# Yucca Mountain Site Characterization Project

## Peer Review Report

## CHLORINE-36 STUDIES AT YUCCA MOUNTAIN

FIGURE 3  
<sup>36</sup>Cl MEASUREMENTS ALONG ESF  
 YUCCA MT/PEER REVIEW/NV

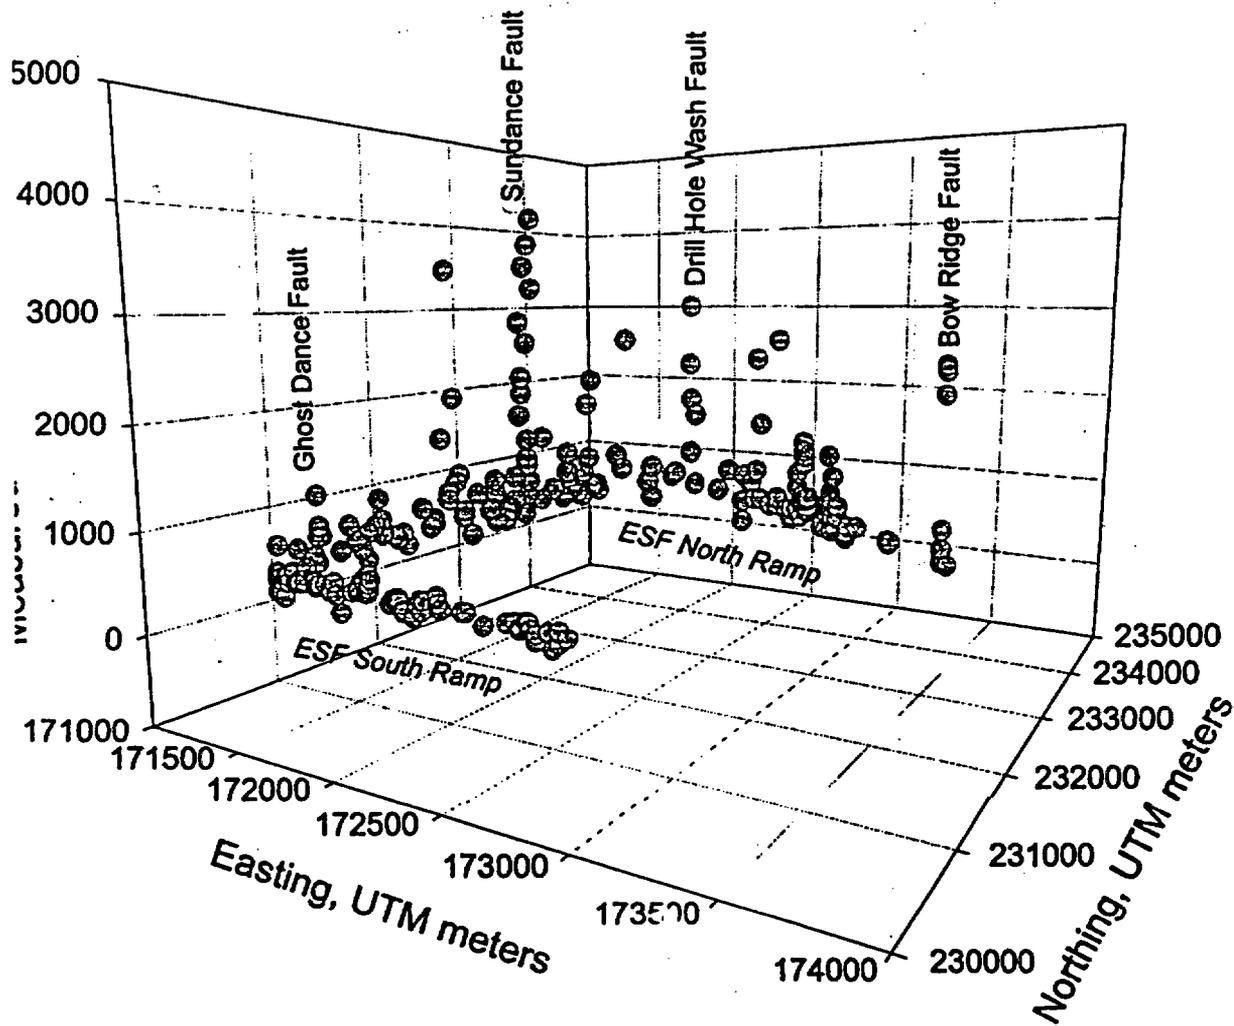
The observations of  $^{36}\text{Cl}$  at the Yucca Mountain site are only partly consistent with the conceptual model described above. There appears to be a relationship between some but not all faults and bomb-pulse nuclide appearances in ESF samples (Figure 3). Also, there

The numerical models reproduce in general the spatial pattern of bomb pulse  $^{36}\text{Cl}/\text{Cl}$ , particularly for the Sundance Fault (figure 3). Other faults, however, do not appear to relate clearly to  $^{36}\text{Cl}/\text{Cl}$  ratios. Furthermore, higher  $^{36}\text{Cl}/\text{Cl}$  ratios in the North ramp rather than the South ramp is contrary to an expectation that a thinner PTn in the south should lead to more bomb pulse  $^{36}\text{Cl}/\text{Cl}$  ratios in that area. Sonnenthai and Bodvarsson (1997, Ch.15) point out that the model predicts higher total chloride concentrations near some faults such as the Ghost Dance fault which can mask the bomb pulse signatures (Figure 6).

FIGURE 4  
 RECONSTRUCTION OF ATMOSPHERIC  
 $^{36}\text{Cl}$  OVER PAST 50,000 YEARS  
 YUCCA MT/PEER REVIEW/NV

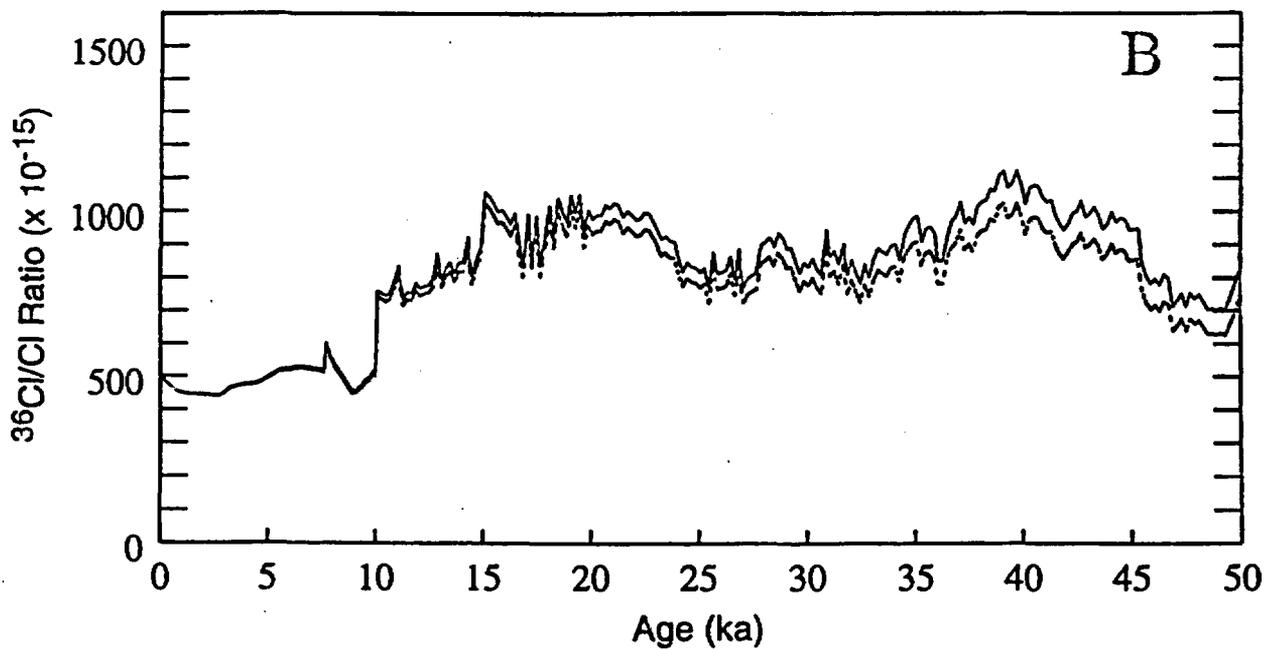
Reconstruction of the  $^{36}\text{Cl}/\text{Cl}$  ratio in atmospheric waters is presented Figure 4 (3-1 of Fabryka-Martin et al., 1997). The reconstruction shows that atmospheric values have averaged about 500 and not exceeded  $600 \times 10^{-15}$  during the Holocene (the last 10,000 years). Decay-corrected values for the Pleistocene (10,000 50,000 years before present) average at about  $800 \times 10^{-15}$  and peak at about  $1000 \times 10^{-15}$ .

For these reasons, the  $1250 \times 10^{-15}$  threshold is conservative in identifying bomb waters. It is very important to note, however, that the corollary is not

FIGURE 5  
**RELATIONSHIP OF  $^{36}\text{Cl}$  TO TOTAL  
 Cl IN ESF PORE SALTS**  
 YUCCA MT/PEER REVIEW: NV

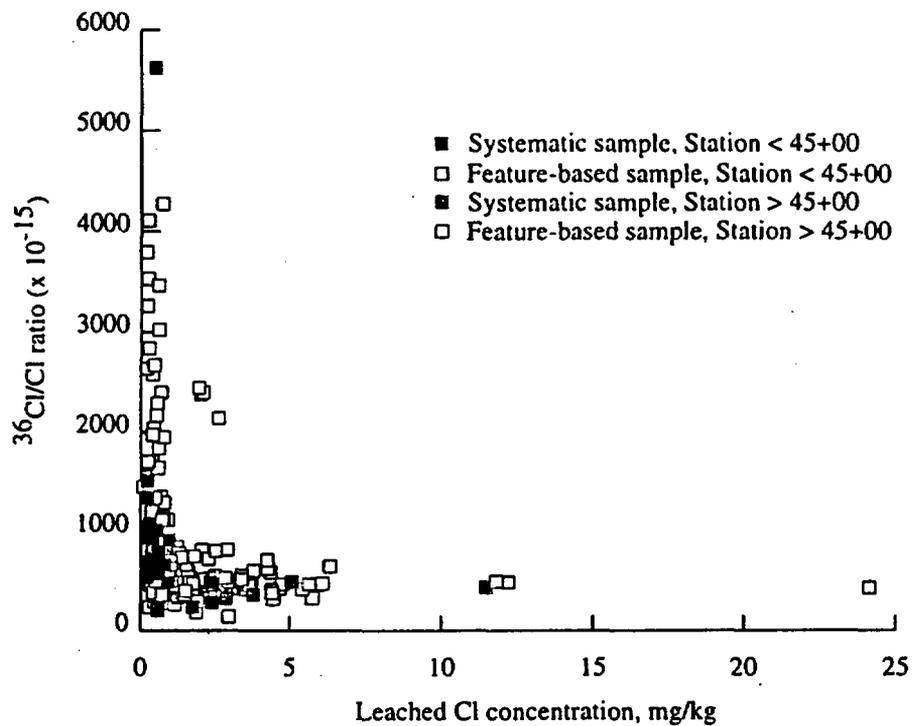
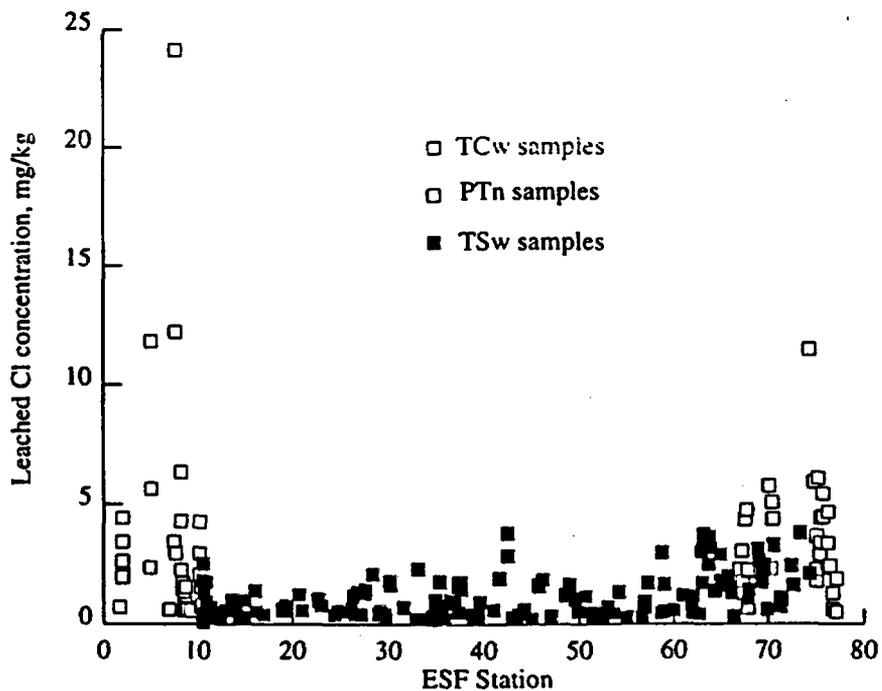
Variable amounts of dilution could bias the interpretation of the  $^{36}\text{Cl}/\text{Cl}$  ratio data. For example, the observation that none of the ESF samples from the south ramp have  $^{36}\text{Cl}/\text{Cl}$  ratios with a bomb pulse signature could be explained by more dilution in samples from that region of the ESF. To examine this question further the PRT requested a series of analysis which were performed by J. Fabryka-Martin using the ESF  $^{36}\text{Cl}/\text{Cl}$  data set. (Fabryka-Martin, 1998 February, Pers. Comm).

These analyses examined a series of potential biases and variations in the amount of dilution that might occur as atmospheric  $^{36}\text{Cl}/\text{Cl}$  ratios are diluted by mixing with rock, pore water, or drill water  $^{36}\text{Cl}/\text{Cl}$ . This analysis allows us to reject the hypothesis that the spatial variations in  $^{36}\text{Cl}/\text{Cl}$  (e.g. the different ratios of  $^{36}\text{Cl}/\text{Cl}$  in the North versus South ESF) can be explained by variable amounts of dilution in different parts of the ESF (Figure 3). Based on this analysis, it would appear that:

- Stratifying the data by lithology does not change these conclusions,
- Several of the TCw samples from the south ramp area have low concentrations of leached Cl; but none of the samples that have been analyzed to date, (additional samples have been collected for analyses) has a high  $^{36}\text{Cl}/\text{Cl}$  ratio ( $>1000 \times 10^{-15}$ ), and.
